- 1.1 This addendum modifies the Bid Documents for the Jennie E. Hughes Park Improvements project.
- 1.2 This Addendum forms a part of the Bidding Documents and will be incorporated into the Contract documents, as applicable.
- 1.3 Acknowledge receipt of all addenda prior to submittal of bid, by reference in the bid form.

JENNIE E. HUGHES PARK IMPROVEMENTS
6448 Sewanee Ave.,
West University Place, TX 77005

NO.	DATE:	DESCRIPTION:
	3/6/2018	100% Construction Drawings
	4/11/2018	Addendum #1

06 ACTIVATOR BOLLARD SCALE: 1-1/2"=1'-0"

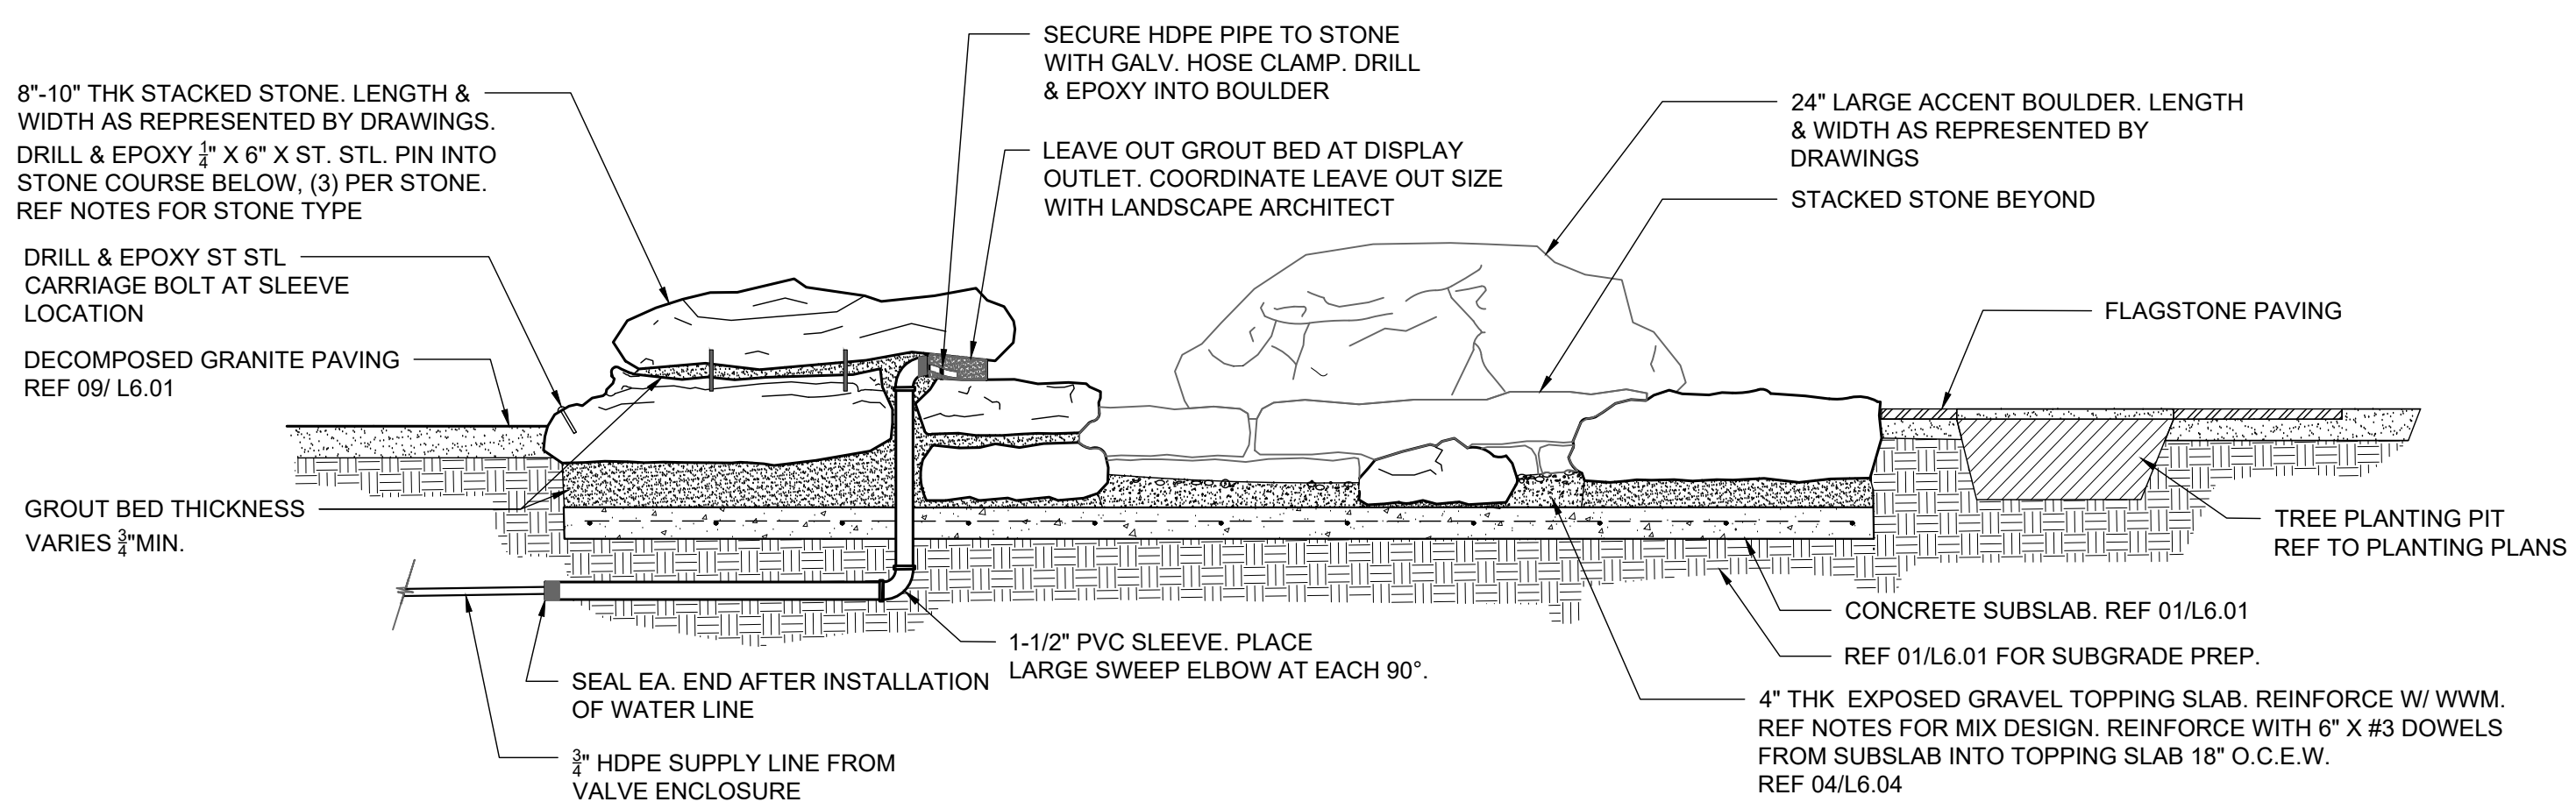
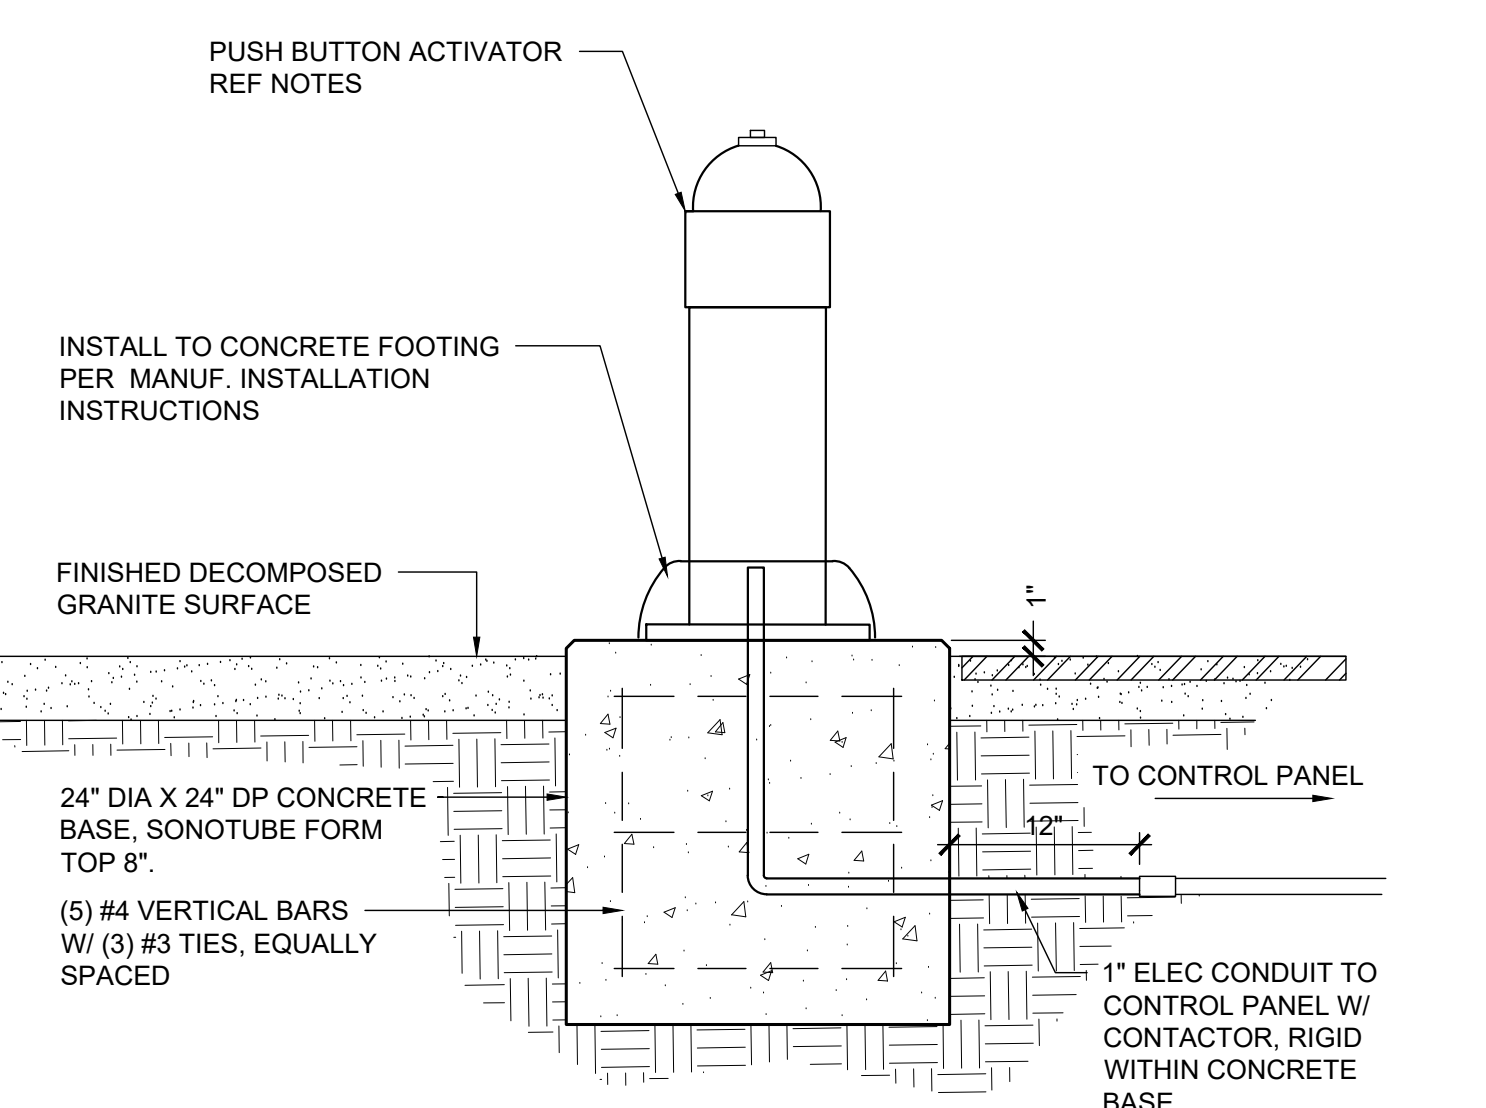
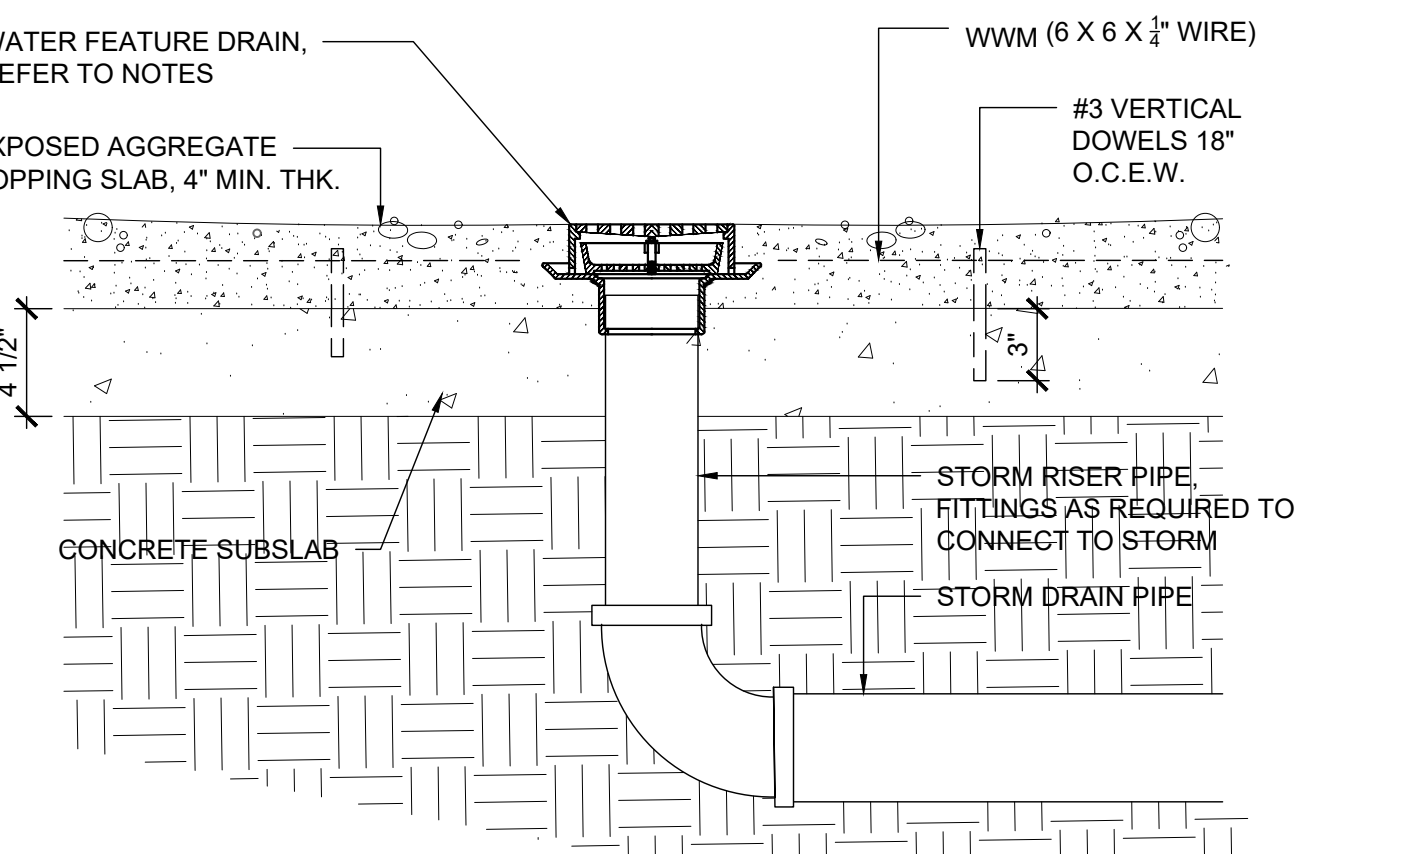
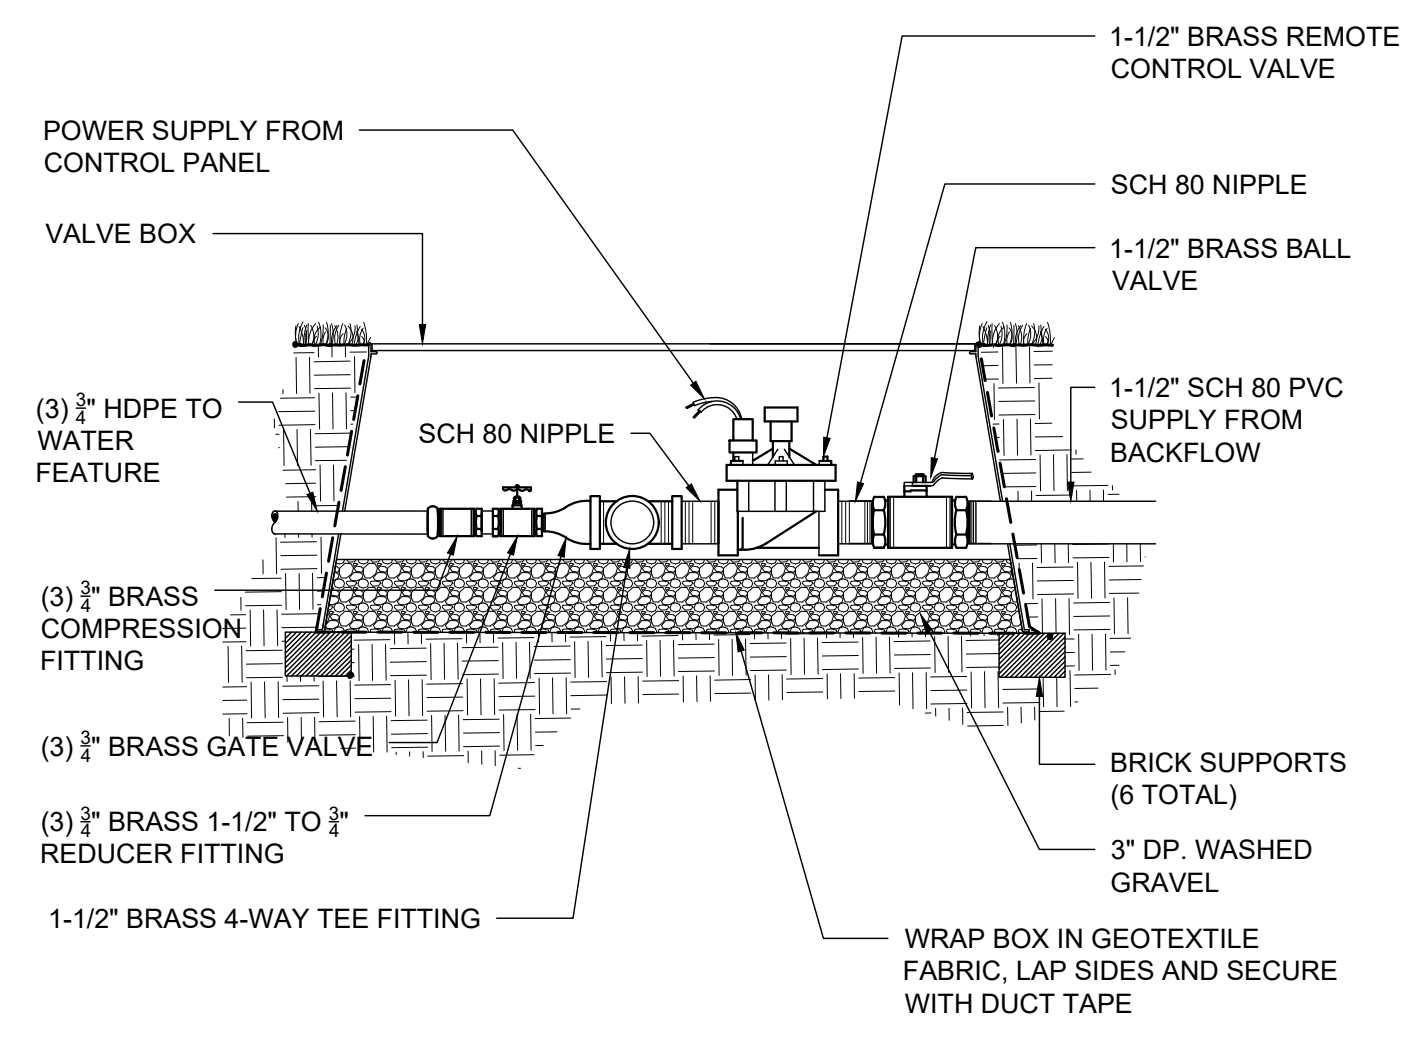
- 3.1 L0.01 - Demolition of concrete unit retaining wall added to scope.
- 3.2 L3.01 – Description of grading work between sidewalk and street curb at previous retaining wall locations provided.
- 3.3 L6.04 – Raindrop representative added to notes. Revised activator bollard model number. Control Panel Timer model number provided. Description of conduit routing provided within detail 01.
- 3.4 L6.23 – Detail path callout revised.
- 3.5 LE1.01 – Service size revised. Additional notes provided. Description of conduit routing provided for activator bollard and water feature valve.

1. Products & Finishes
 - 1.1. Raindrop Products - Contact Steven Bearden 951.310.1491 - sbearden@rain-drop.com.
 - 1.1.1. Activator Bollard - (BOL-005) by Raindrop Products. Submit standard colors for selection.

- 1.1.2. Control Panel Timer - (TMR-008) by Raindrop Products.
 - 1.2. Valve Box - Carson T324, Black lid w/ Drop-N-Lock option.
 - 1.3. Valve - 1-1/2" Brass remote control valve, Rainbird EFB-CP.
